COMMITTEE ACTION REPORT

UNRESOLVED ISSUES (Report of January 3, 2014)

AUGUST 21, 2014

ASC/ICC A117.1 STANDARD DEVELOPMENT - 2015 EDITION*

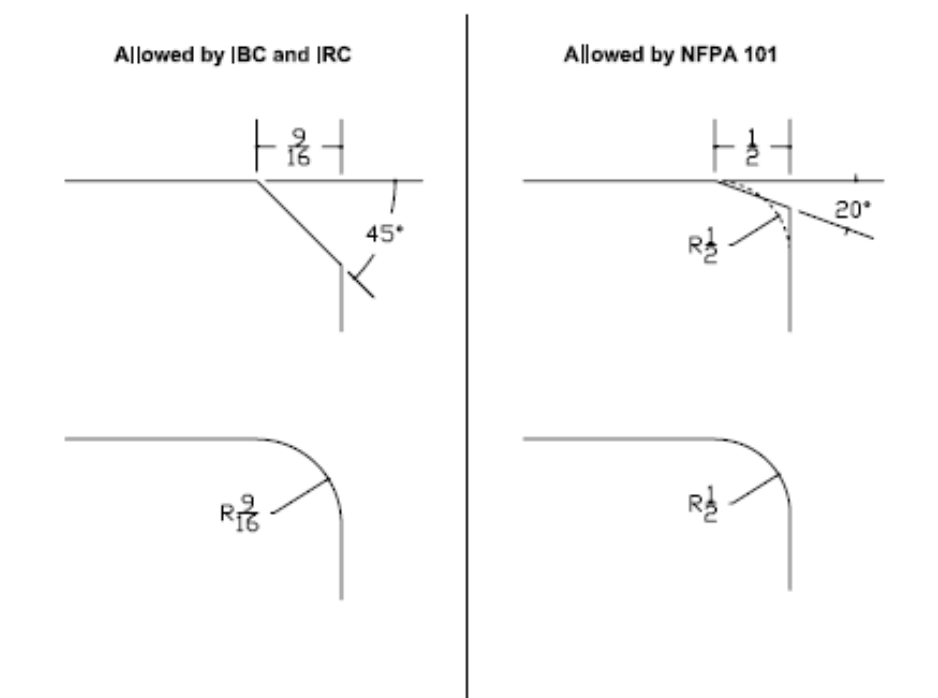
Approve Proposal 4-33-12 with modifications: The modification is a substitute proposal for the original submittal:

404.3.1 Public Entrances. Where an automatic door is required at a building or facility public entrance, it shall be a full powered automatic door or a low-energy door. Where the entrance includes a vestibule that has exterior and interior entrance doors, at least one exterior door and one interior door in the vestibule shall be either a full powered automatic door or a low-energy door.

Clarification is needed regarding automatic doors used in vestibules. The proposed vestibule language is from GSA Facilities Standard P100. Both doors need to be either full powered or low-energy to support the concept of getting people completely inside a building or facility.

5-11-12 Figure One

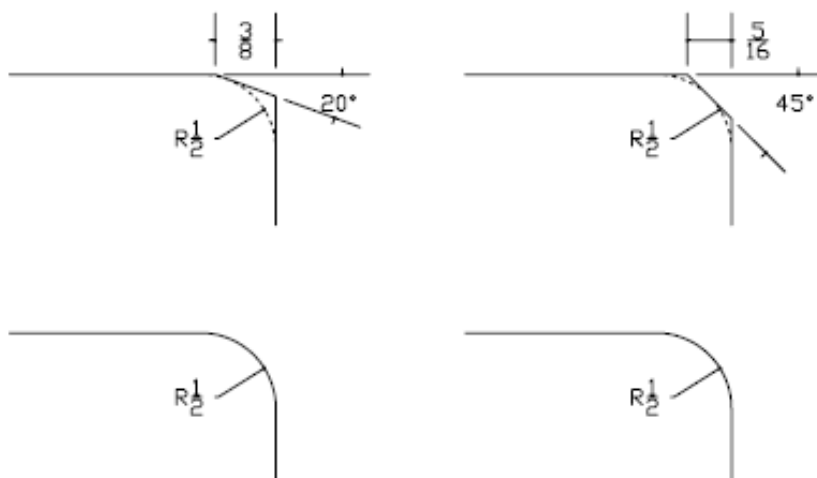
Reason: The committee needs to reconsider the intent of this proposal modified and approved at the July meeting. It has been misunderstood and is a needed proposal. Figure one provides a graphic explanation to clarify the limits and provides a comparison to what is allowed in other codes mentioned in prior comments.

504.5 Nosings. Nosings shall be curved or beveled. The radius of curvature at the leading edge of the tread shall ~~be not exceed the limit described by a ½ inch (13 mm) radius maximum.~~ A bevel shall not exceed the limit described by a plane that is tangent to a ½ inch (13 mm) radius of curvature at the leading edge of the upper surface of treads. Nosings that project beyond risers shall have the underside of the leading edge curved or beveled. Risers shall be permitted to slope under the tread at an angle of 30 degrees maximum from vertical. The permitted projection of the nosing shall be 1 ½ inches (38 mm) maximum over the tread or floor below.

As angle of bevel increases the encroachment on the tread decreases and increases the flat surface of the tread due to the limit imposed by the 1/2 Inch radius.

Approve with modifications – Proposal 5-11-12

504.5 Nosings. Nosings shall comply with 504.5.1 through 504.6.3.

504.5.1 Nosings within a stairway shall be uniform.

504.5.2 If rounded, the radius of curvature at the leading edge shall be 1/2 inch (13 mm) maximum.

504.5.3 If beveled, the bevel shall slope at 45 degrees to the plane of the top surface of the tread and landing and extend for a horizontal distance of 1/2 inch (13 mm) maximum.

FIGURE 2 for Issue 5-11-12

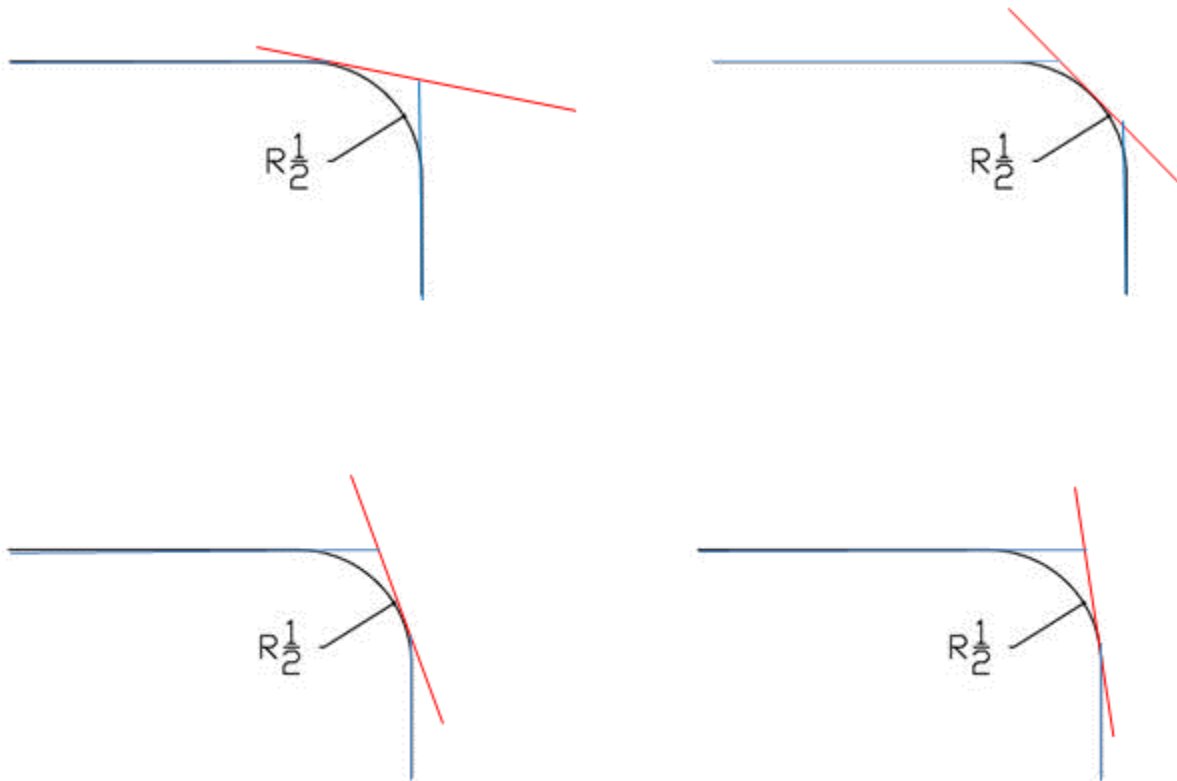
The following **figure 2** shows a section through the tread at the nosing and upper surface of the tread. The “limiting plane” is described as a red line. In each example the “limiting plane” is shown tangent to different points on the $\frac{1}{2}$ inch (13mm) radius of curvature.

Existing ANSI 608 Standard Roll-in Shower

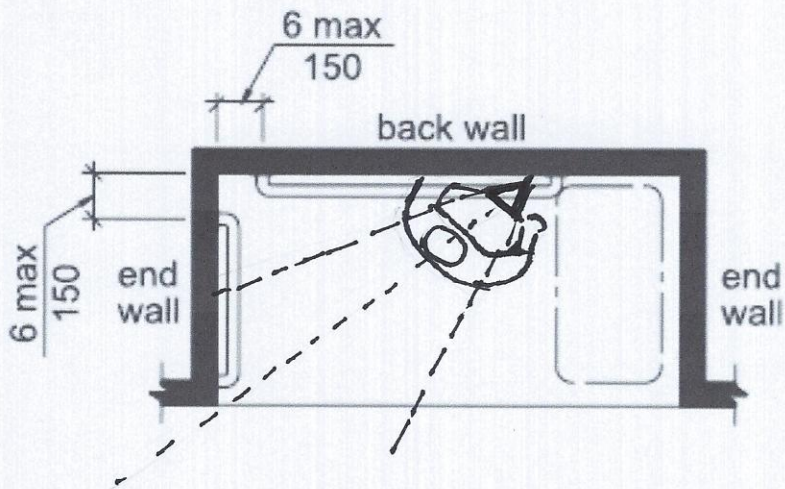
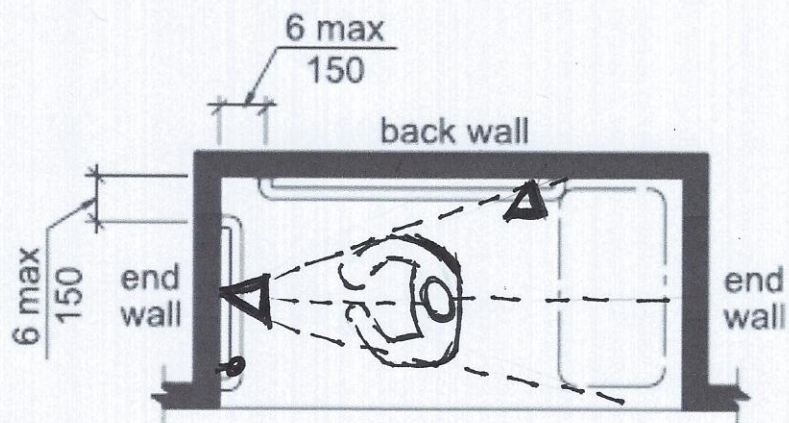
Reason: Many people with walking disabilities prefer to walk into the shower and stand while they shower. People with walking disabilities frequently have knee or hip problems that severely restrict their ability to easily sit and rise from a wet shower seat. The roll-in shower controls and spray located on the back wall are not easily usable by a person who prefers to stand and use the grab bars while showering because the water sprays out into the room and their elbows hit the back wall. Provide option for additional Ambulatory Roll-in Shower Controls and Hand Shower. See sketches at end.

- Half the spray goes out into the room.
- Person must stand as close as possible to spray and their elbows hit the back wall

- Controls and Hand Shower located on end wall I
- Vertical Grab Bar provided by standing entry

Approve proposal 6-61-12 as outlined above.

Reason: The proposal allows more flexibility in the use of roll-in showers for persons who are ambulatory and not just those who use a wheelchair or other mobility device.
